SUBJ: **Addendum 2 – New Bid Opening Date and Clarifications to the Specifications**

BID ITEM: **Bid Item #23-150 Construction - Airfield Electrical System Upgrade for Runways 5-23 & 11-29 for Augusta, GA – Daniel Field Airport**

**ADDENDUM NO. 2**

**E22**  
 Sheet 46 of 52

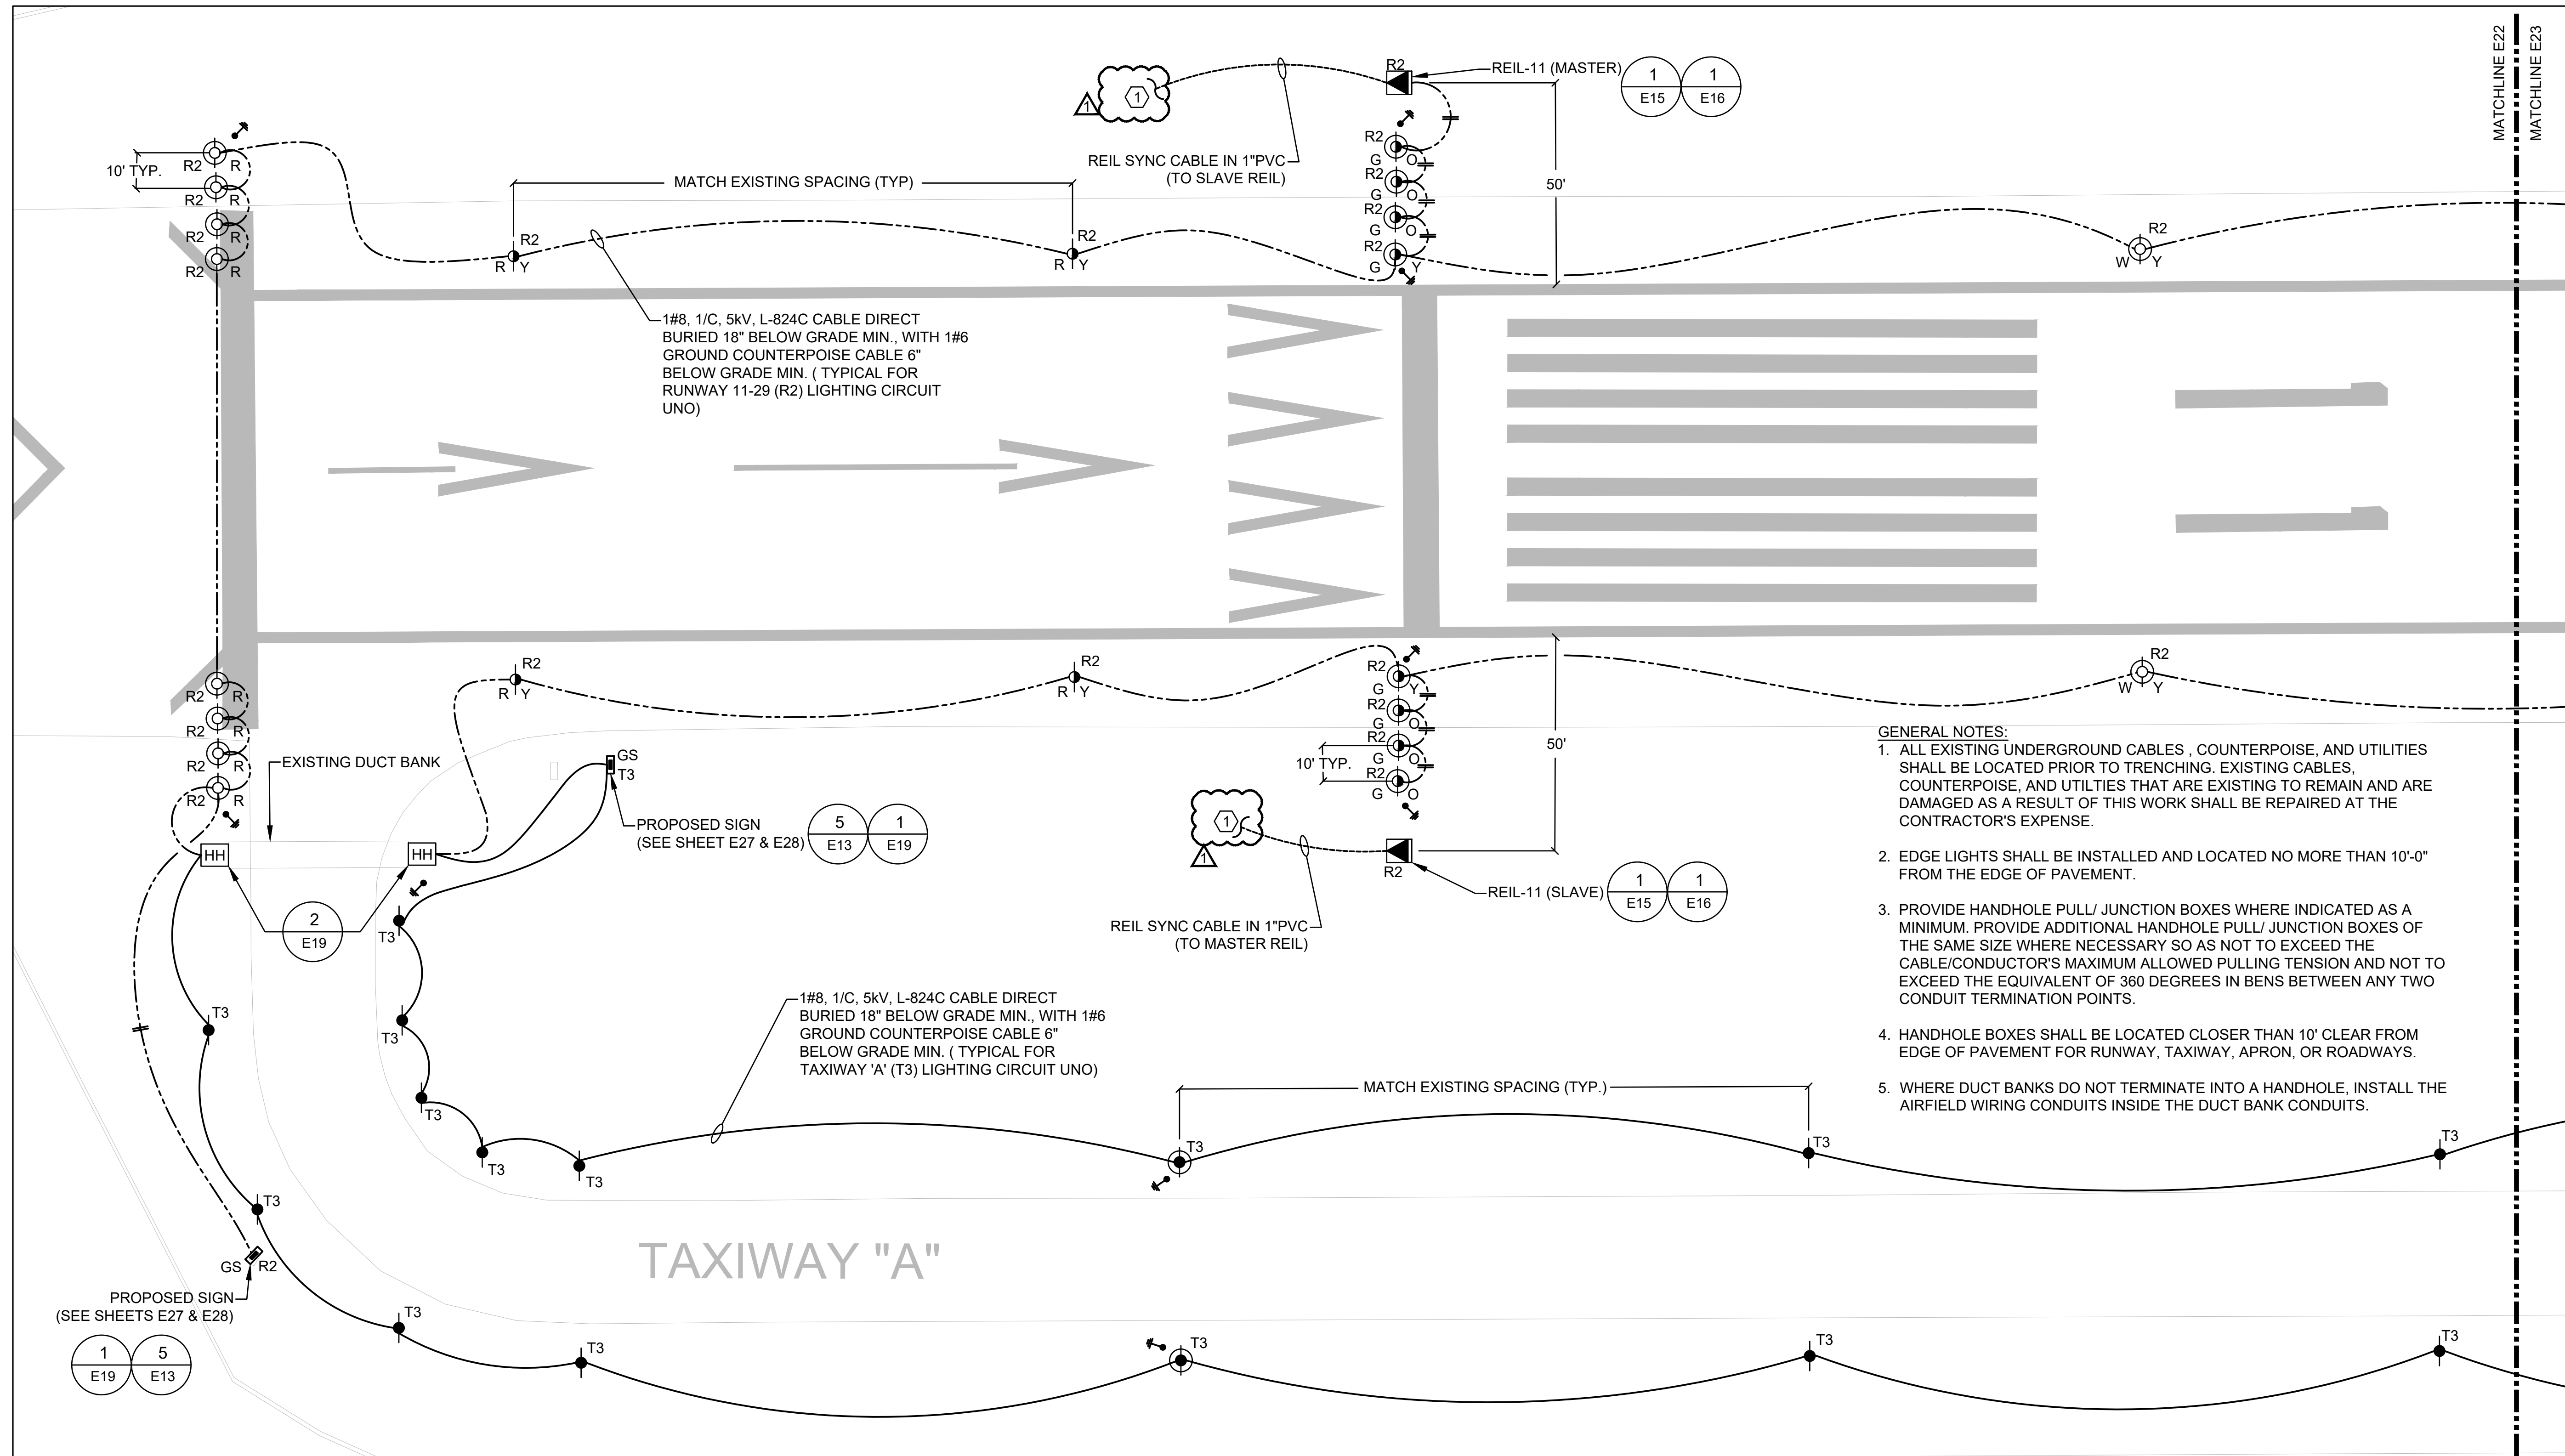
- D. **Replace Sheet E7** – Airfield Lighting & Wiring Plan Runway 5/23 – Part 7 with revised Sheet E7 attached to this Addendum 2.
- Conduit size for Wind cone Circuit revised to 1” C.
- E. **Replace Sheet E22** – Airfield Lighting & Wiring Plan –Runway 11/29 - Part 1 (ADD) with revised Sheet E22 attached to this Addendum 2.
- Keynote 1 revised to add note stating “ Route cable around Runway 11 end threshold as required.”
  - General Note has been revised, See Section III Clarification Notes of this Addendum 2.
- F. **Replace Sheets E23-E26** – Airfield Lighting & Wiring Plan –Runway 11/29 - Parts 2-5 (ADD) with revised Sheets E23-E26 attached to this Addendum 2.
- General Note has been revised, See Section III Clarification Notes of this Addendum 2.

- General Note on Sheets E22-E26 have been revised to state that “Contractor has option to match existing routes and route new cables in existing trenches, duct banks, etc. New cabling consists of: 1#8, 5kV, L-824C Direct Buried 18” below grade min. (Typical for one (1) Runway (R2) lighting circuit and one (1) Taxiway ‘A’ (T3) lighting circuit uno)**
- All runway edge lights on Runway 5/23 & Runway 11/29 are equipped with existing paved shoulders in asphalt from grade to existing lighting fixtures. Contractor to utilize existing conduit, or raceways in existing paved shoulders to route new cabling direct buried in grade to existing paved shoulders and continue to route new cabling in existing conduit/raceways to new lighting fixtures. Contractor to verify existing conduit/raceways are in good condition and code complaint. See Revised sheet GE1 attached to this Addendum 2.**
